MIL-A-8591G
AMENDMENT 5
14 August 1987
SUPERSEDING
MIL-A-8591G
AMENDMENT 4
7 May 1987

MILITARY SPECIFICATION

AIRBORNE STORES, SUSPENSION EQUIPMENT AND AIRCRAFT-STORE INTERFACE (CARRIAGE PHASE); GENERAL DESIGN CRITERIA FOR

This amendment forms a part of Military Specification MIL-A-8591G, dated 1 December 1983, and is approved for use by all Departments and Agencies of the Department of Defense.

FIGURE 4. Location of store case components, 14-inch lug stores, for carriage on 14-inch lug racks.

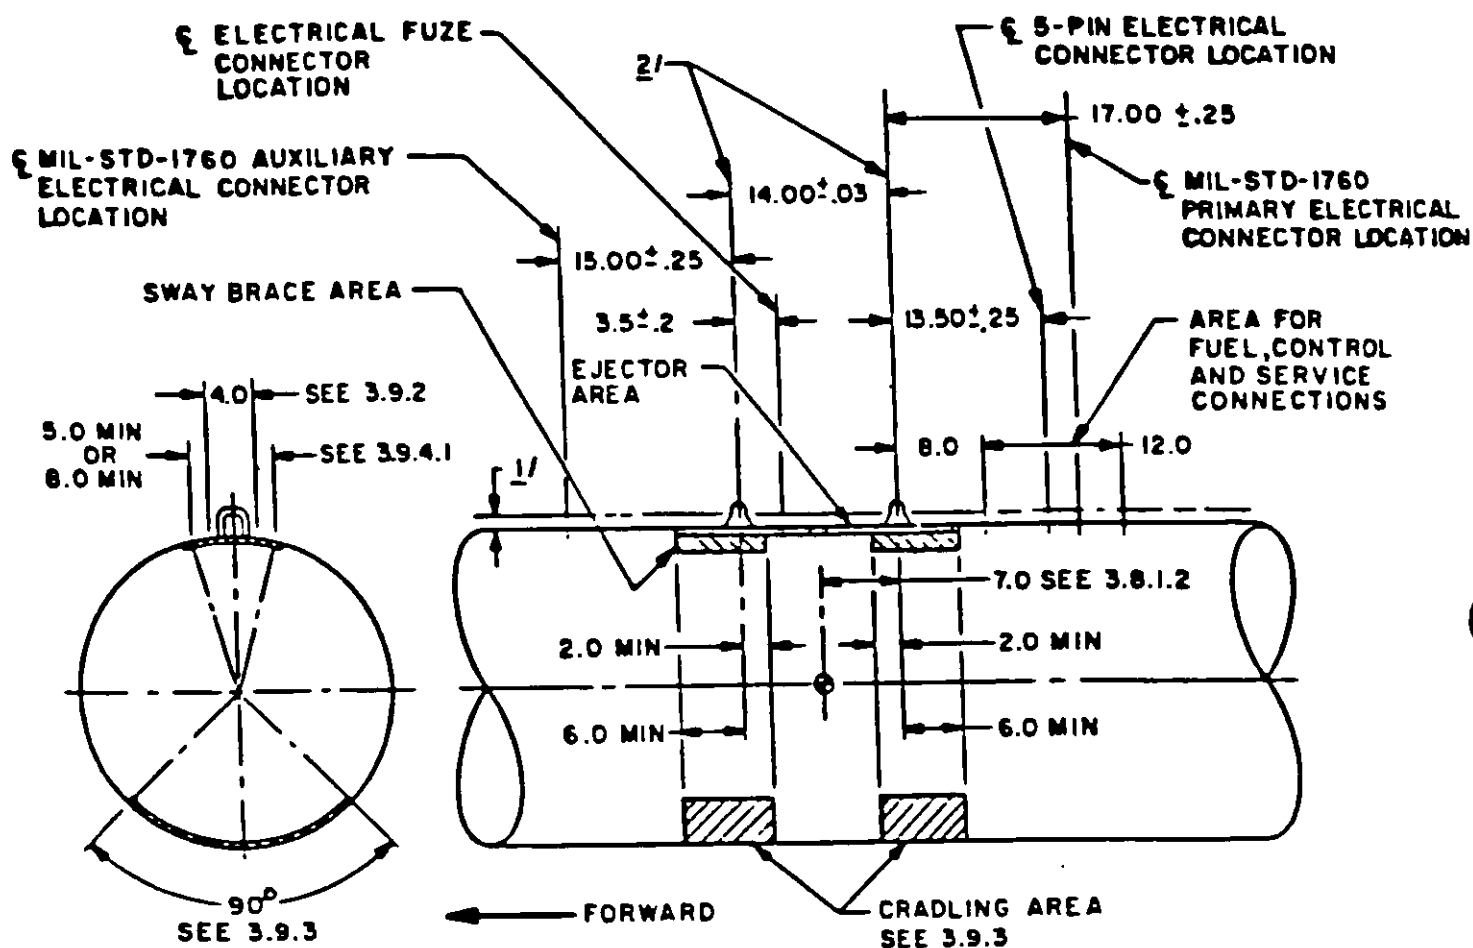
Delete Figure 4 and Notes in their entirety and substitute:

- 1/ A minimum 0.625 inch clearance shall be provided between the rack lower surface and the store upper surface. This clearance shall not apply to rack hooks, braces, ejectors, store lugs or service connections.
- 2/ Lug and lug well axes shall be normal to the store longitudinal axis within $\pm 1/2^\circ$ and in the same plane within $\pm 1/2^\circ$.
3. Dimensions are in inches.

FIGURE 5. Location of store case components, 14-inch lug stores, for carriage on 14 or 30-inch lug racks.

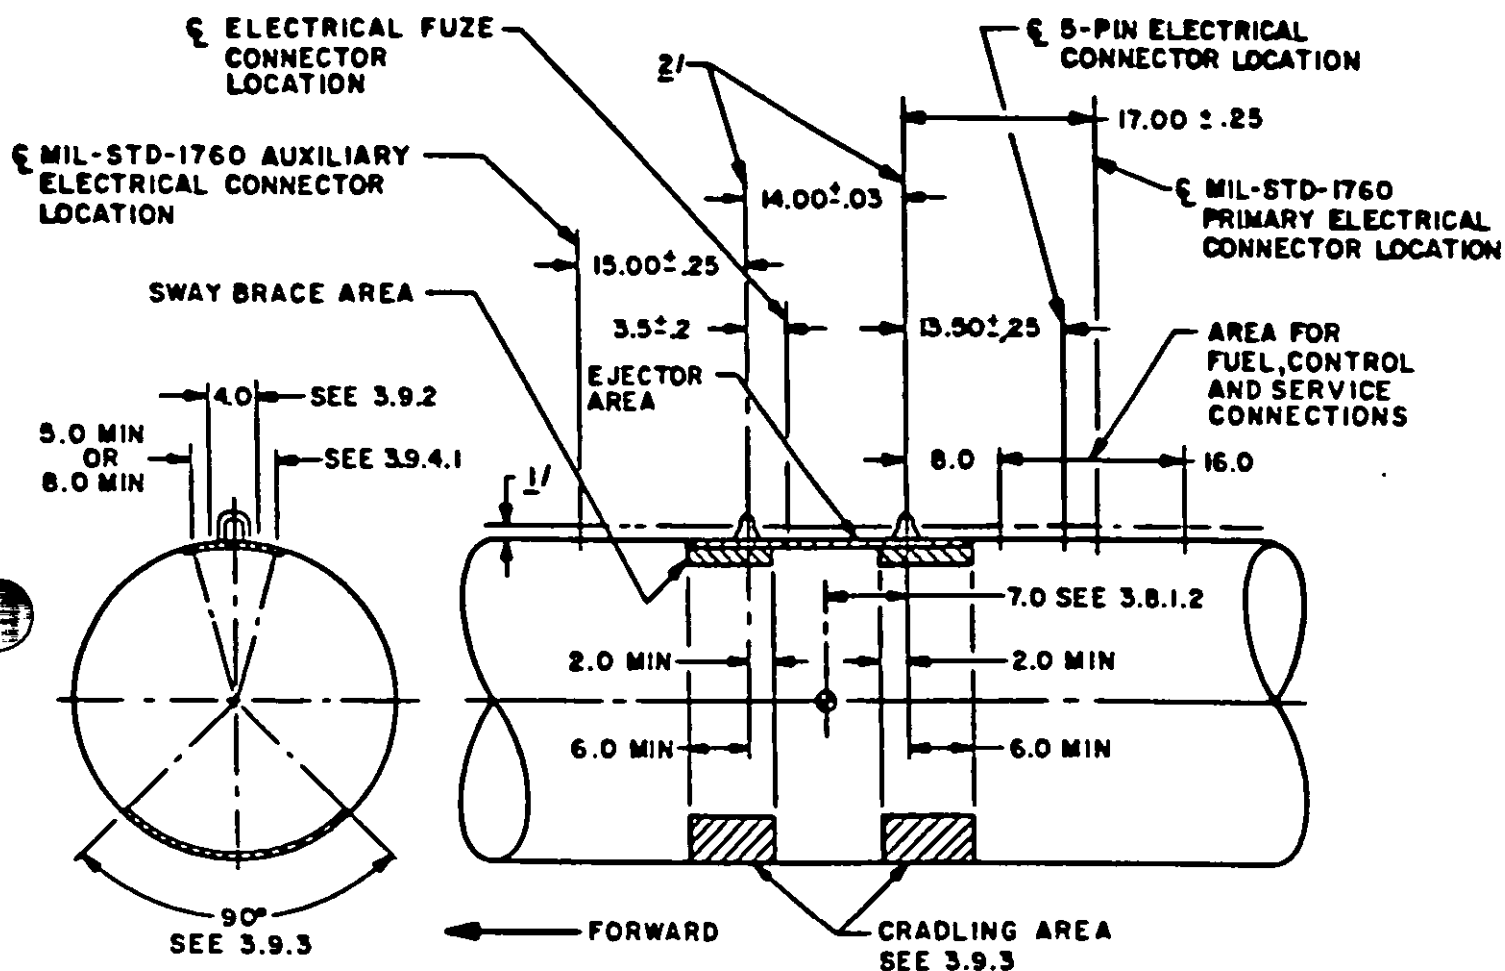
Delete Figure 5 and Notes in their entirety and substitute:

- 1/ A minimum 0.625 inch clearance shall be provided between the rack lower surface and the store upper surface. This clearance shall not apply to rack hooks, braces, ejectors, store lugs or service connections.
- 2/ Lug and lug well axes shall be normal to the store longitudinal axis within $\pm 1/2^\circ$ and in the same plane within $\pm 1/2^\circ$.
3. Dimensions are in inches.

FIGURE 6. Location of store case components, 30-inch lug stores, for carriage on 30-inch lug racks.

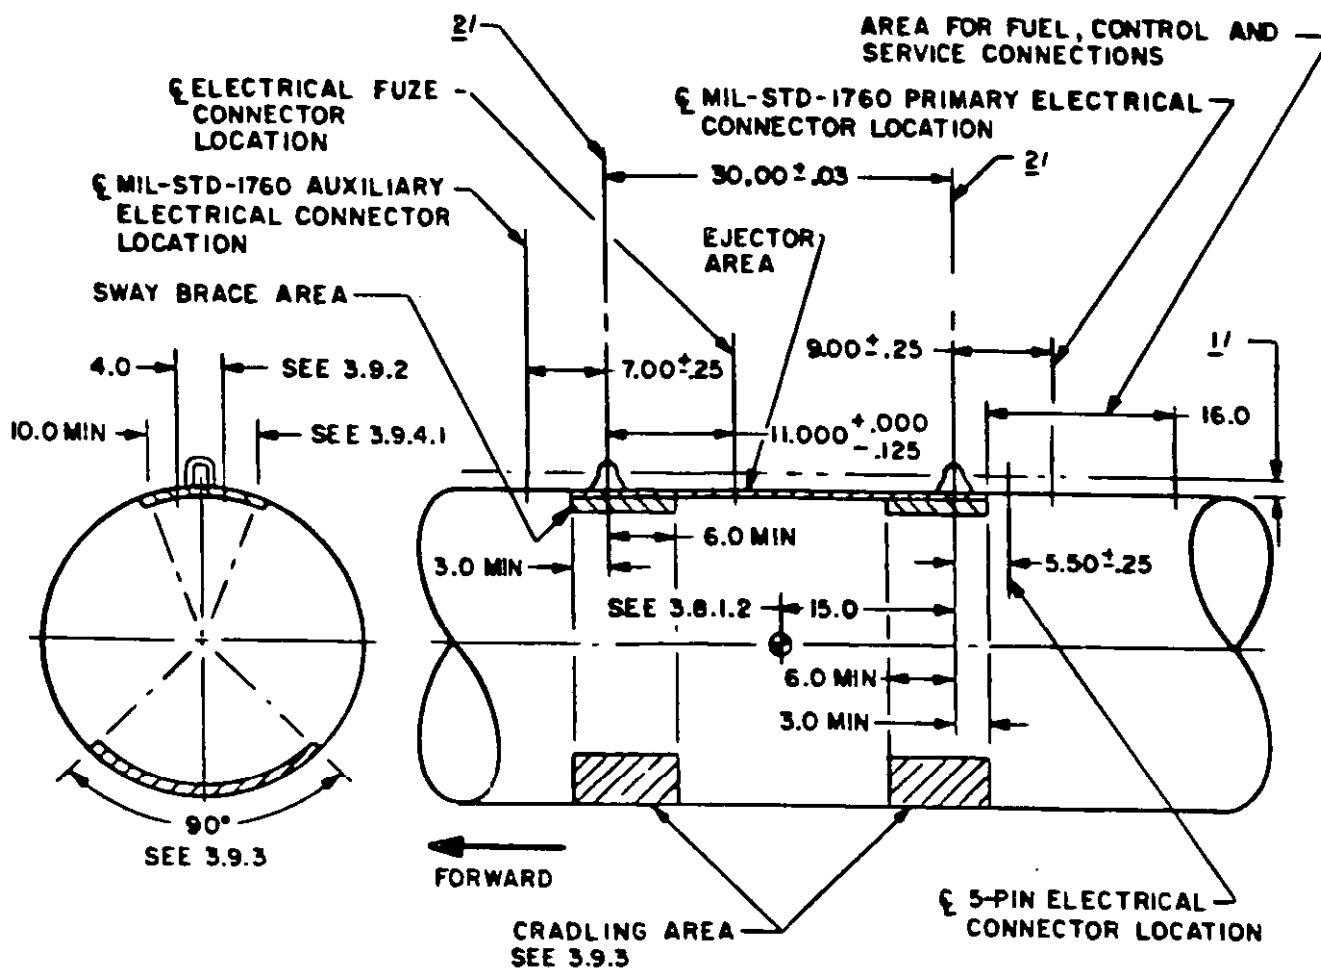
Delete Figure 6 and Notes in their entirety and substitute:

- 1/ A minimum 0.625 inch clearance shall be provided between the rack lower surface and the store upper surface. This clearance shall not apply to rack hooks, braces, ejectors, store lugs or umbilical connections.
- 2/ Lug and lug well axes shall be normal to the store longitudinal axis within $\pm 1/2^\circ$ and in the same plane within $\pm 1/2^\circ$.
3. Dimensions are in inches.
